H10867

HYDROGRAPHIC TITLE SHEET

General locality Penobscot Bay

Localities Searsport to Turtle Head

Figure 1

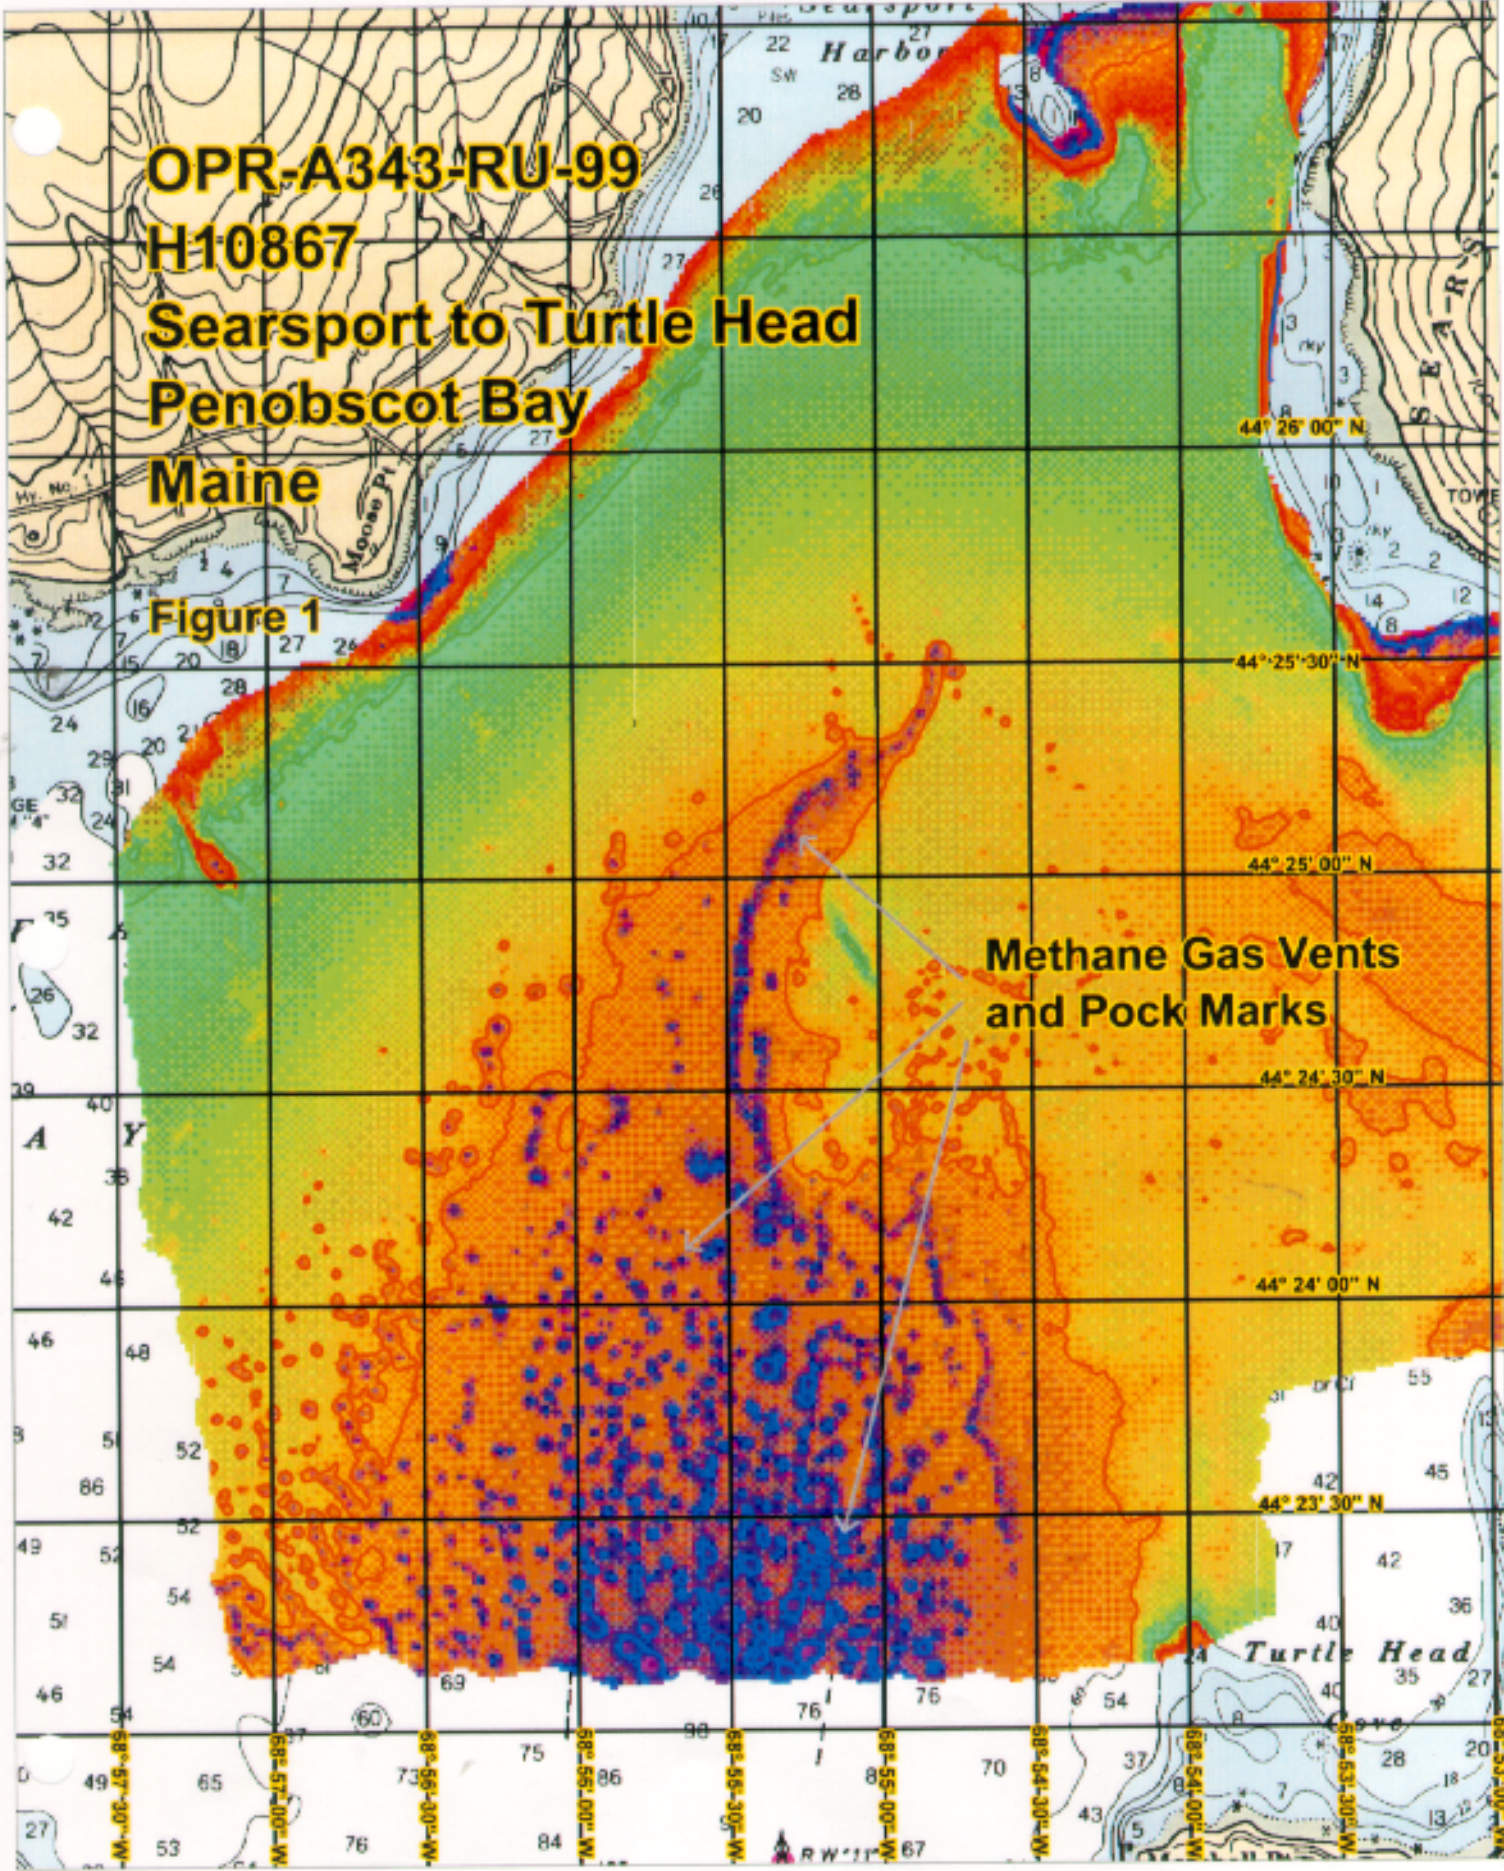
N.3j The southwestern survey area exhibits an extremely irregular profile and contains deep circular or conical

holes scattered throughout this region. This area can be delineated by drawing lines from the general vicinity of 44°25'37"N, 068°55'04"W at the north apex; 44°23'13"N, 068°54'20"W at the southeastern corner; 44°25'08"N, 068°55'30"W at the southwestern corner. This region contains soundings that require revision. *Concur*

Professors from the University of Maine have been studying this location for several years. Information provided for comparison of their previous studies indicated that this region is geologically active. The pock marks or holes are the results of methane gas vent eruptions. Approximately 14,000 years ago an advancing glacier covered decomposing sediments. With time these sediments accumulated methane gas as a by product of the decomposing material. As the gas accumulated, the pressure reached terminal capacity of the overlying sediment and was released with explosive characteristics. The outcome of the gas release is characterized by the pock marks scattered along the bottom. The explosive gas release allowed the overlying sediment to be dispersed within the water column, ultimately settling to the bottom of the bay. Survey data has evidence of several pock marks reaching over 20 meters in depth. The hydrographer recommends revising Chart 13309 as depicted by hydrographic data collected during this survey. See Figure 1 (next page). *Concur*

CHART: 13309/ 13302

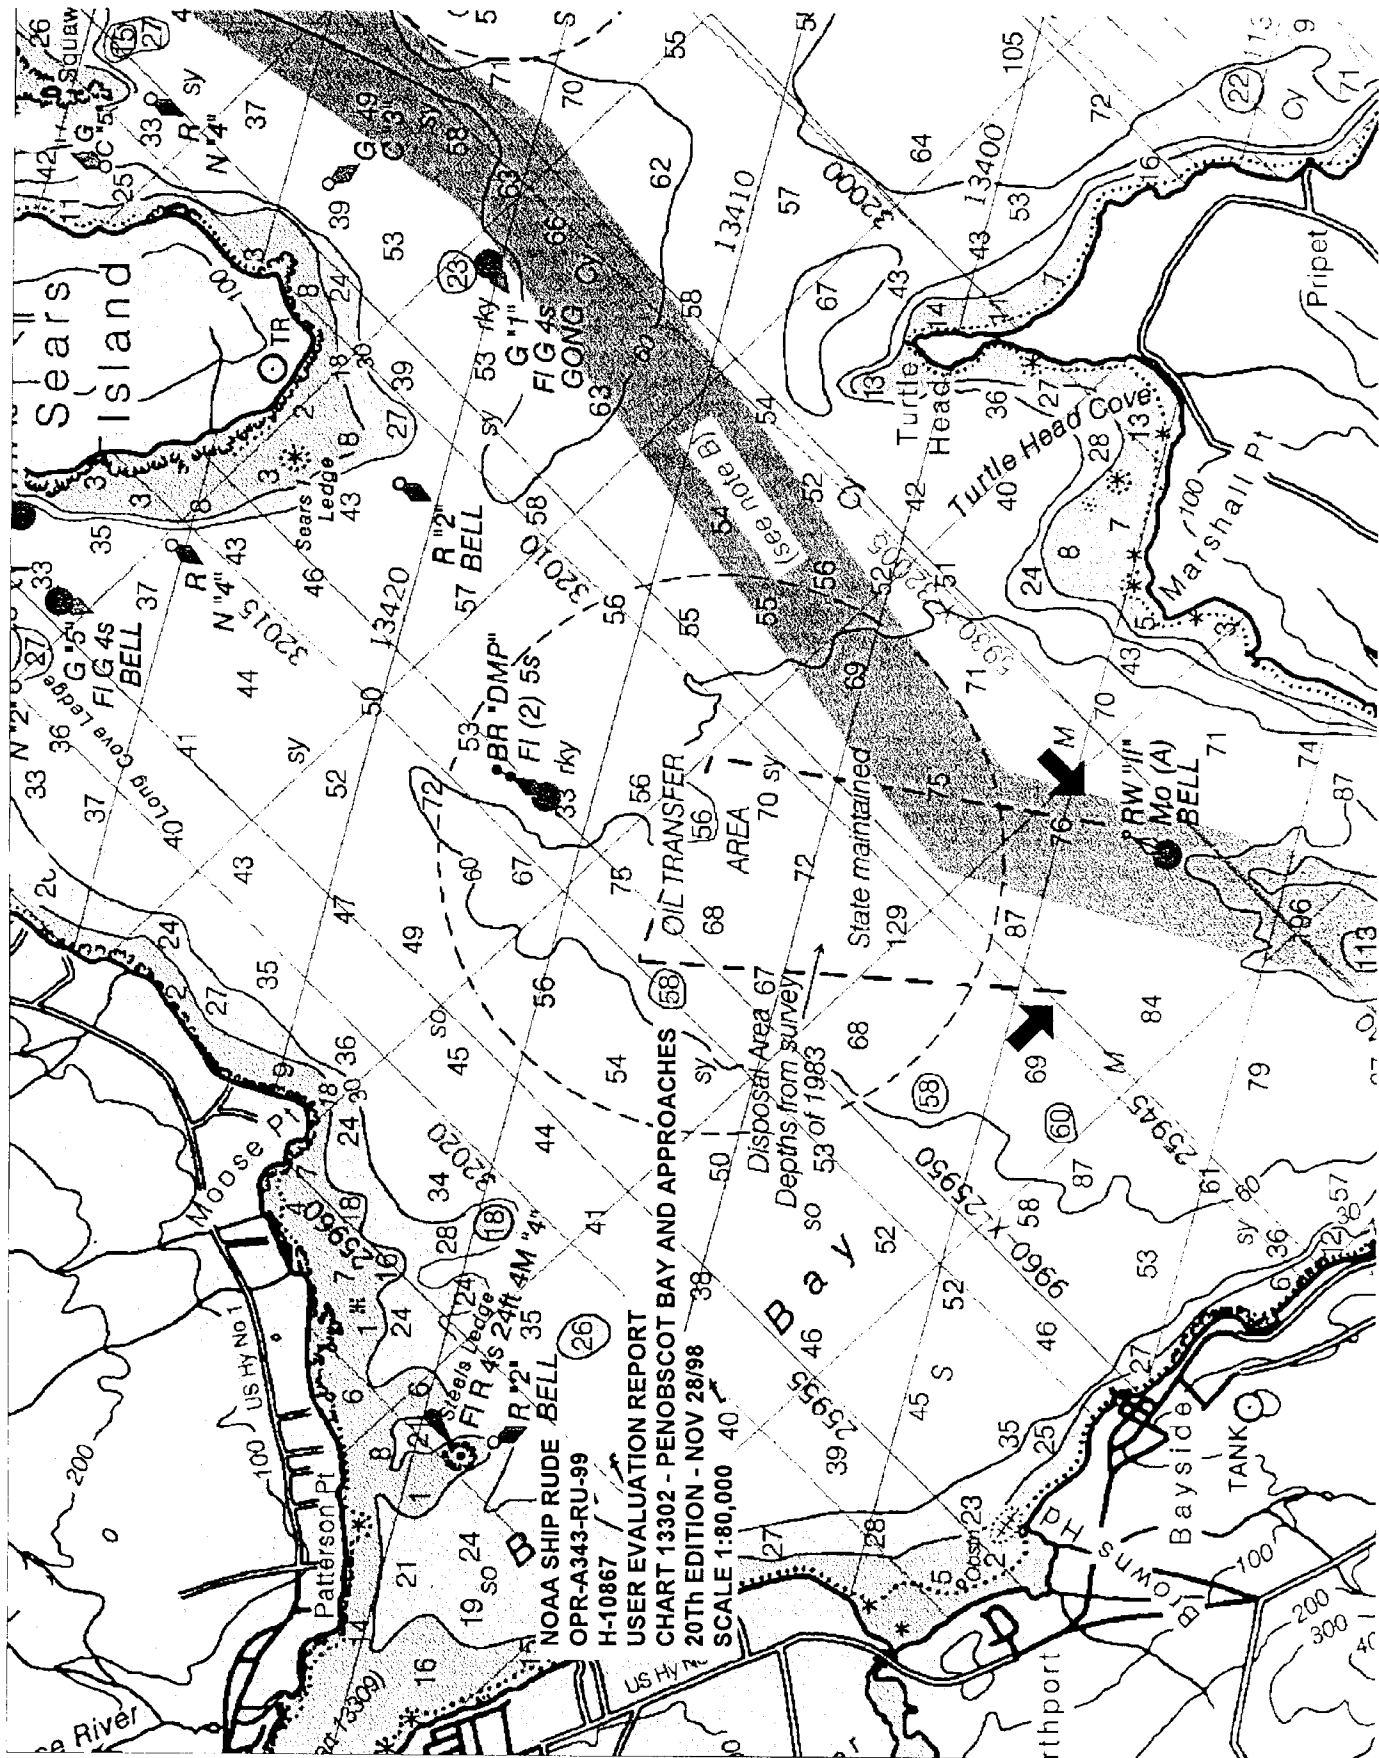
Boundary omitted on southern end of disposal area (between RED ARROWS).

CHART: 13309/ 13302

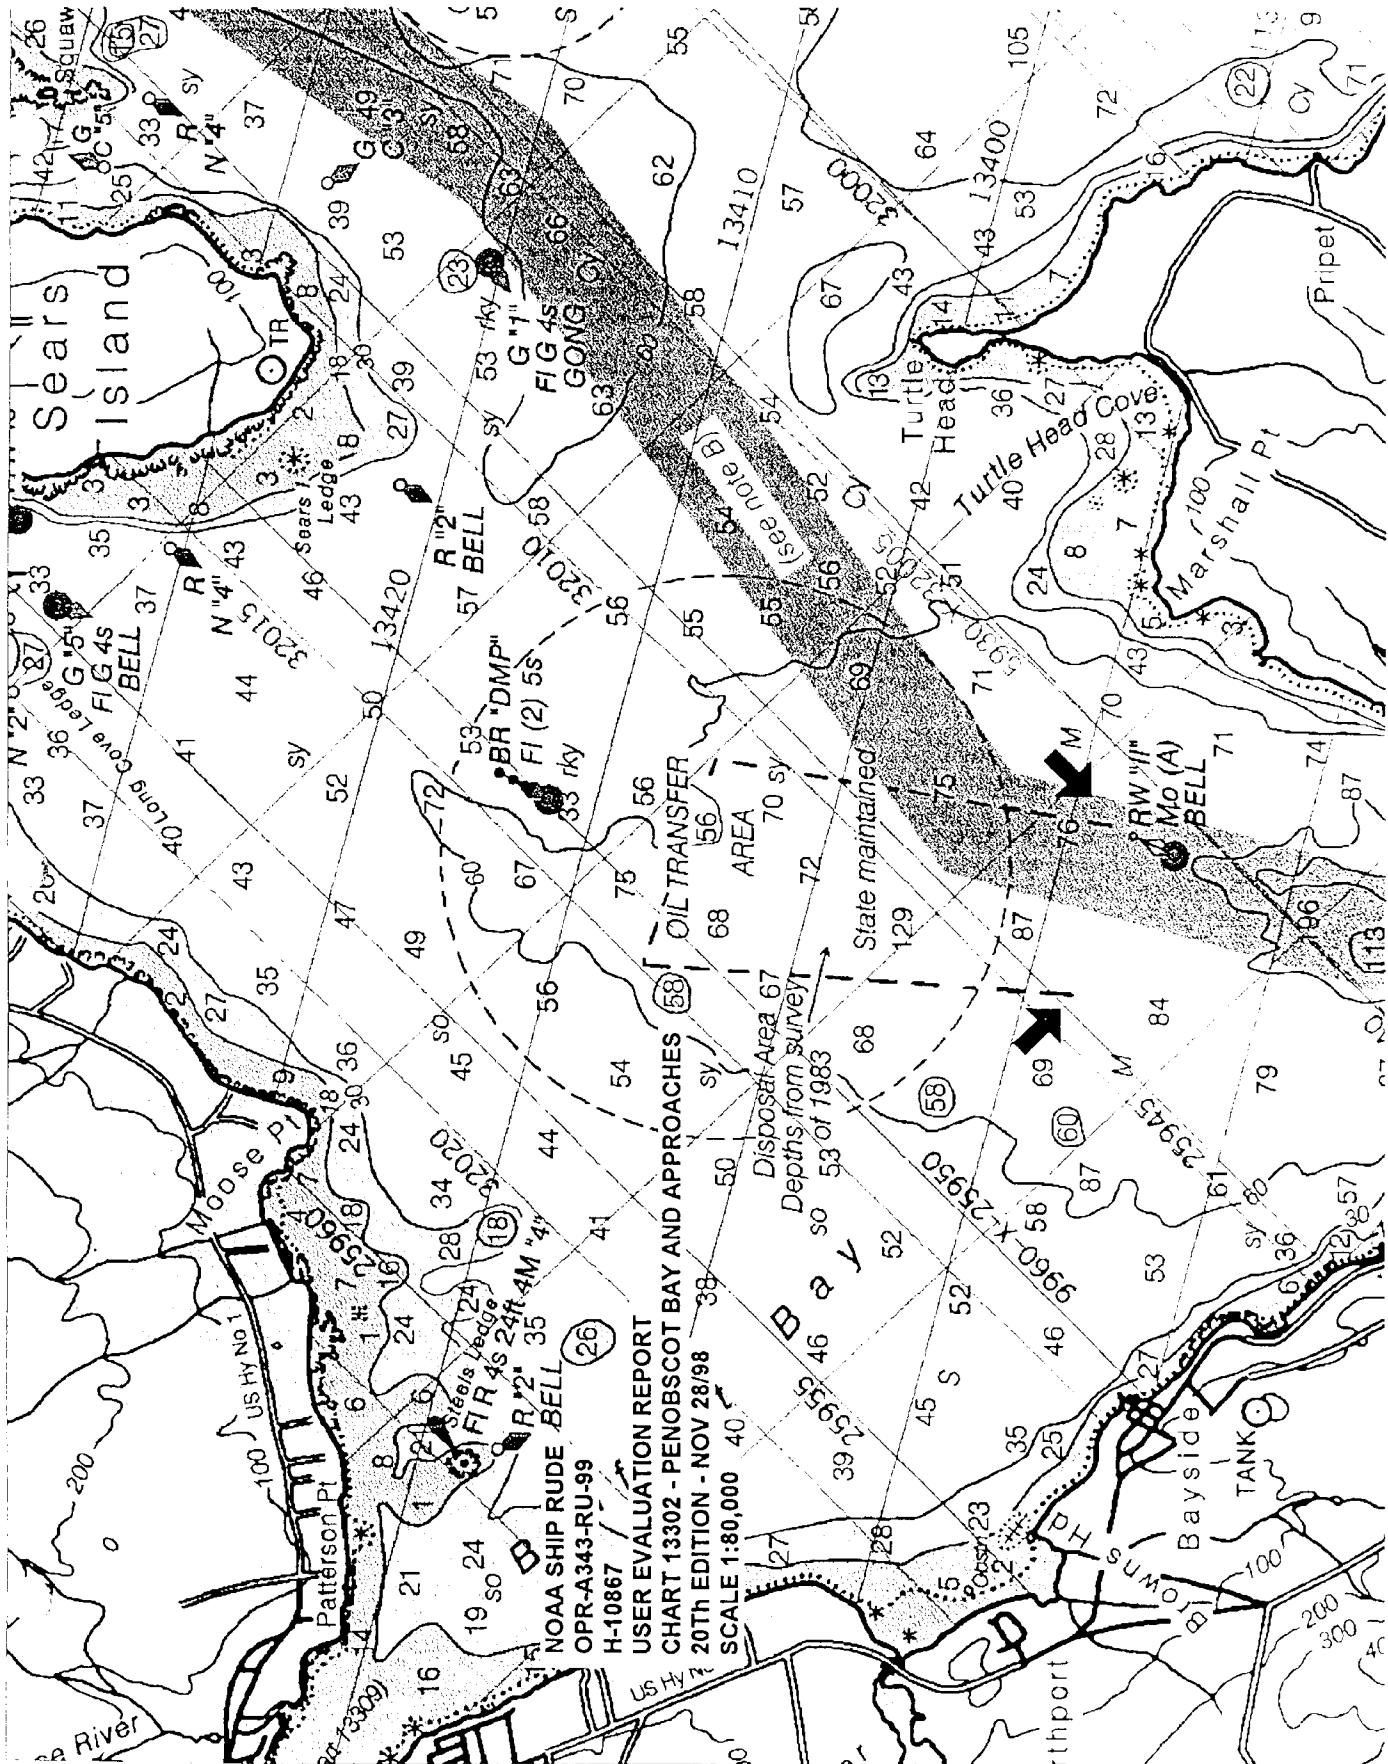
Boundary omitted on southern end of disposal area (between RED ARROWS).
